Arboricultural Consultation Response (conditions)

Application No: 25/80150/COND	**Location:** Rheola Broadleas St Ives
Case Officer: KS	**Proposals: Discharge of Condition 3 (Tree Protection Plan) and 4 (AIA)**

July 2022 –

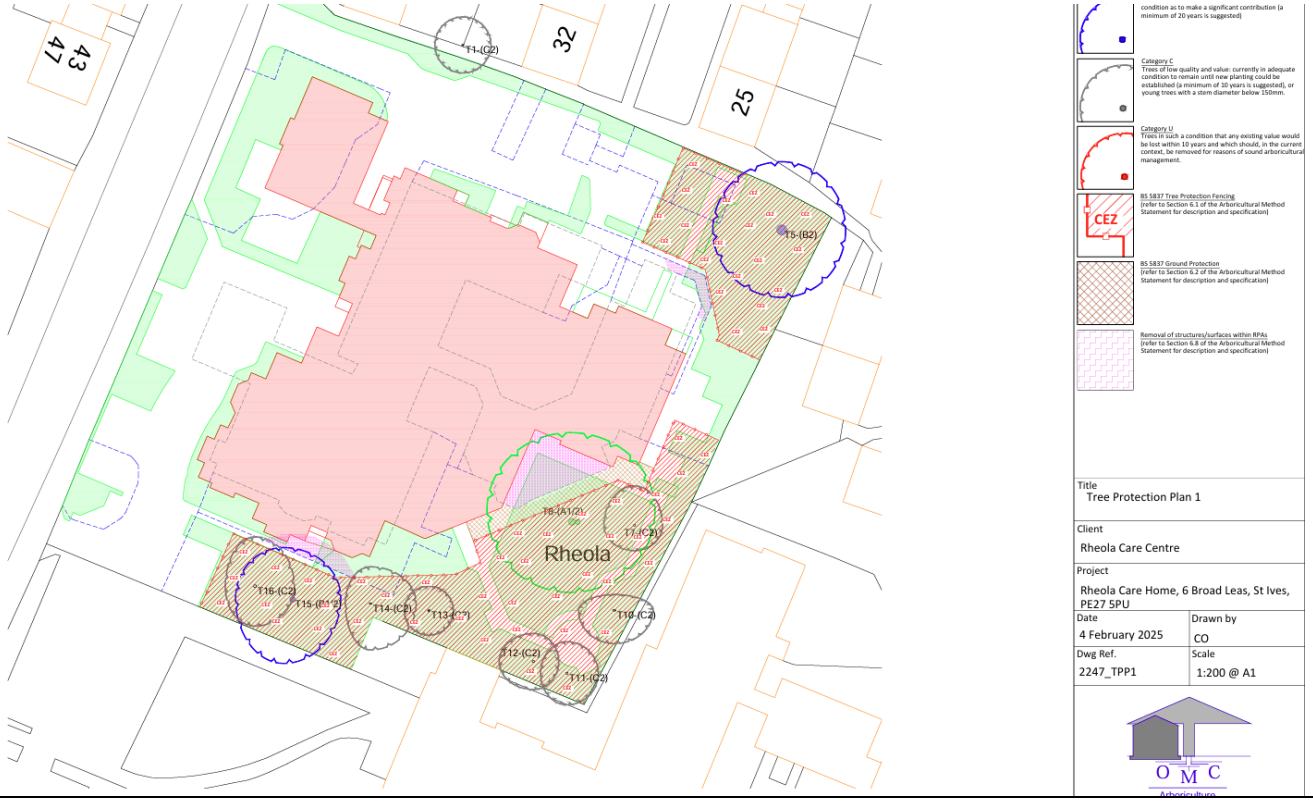
It is noted that the canopy appears to extend over the newly constructed building by some distance. The original indicates that this would not be the case.

The Root Protection Areas are not shown on the new documents, so it is not possible to ascertain the degree of encroachment or if the protection is appropriate.
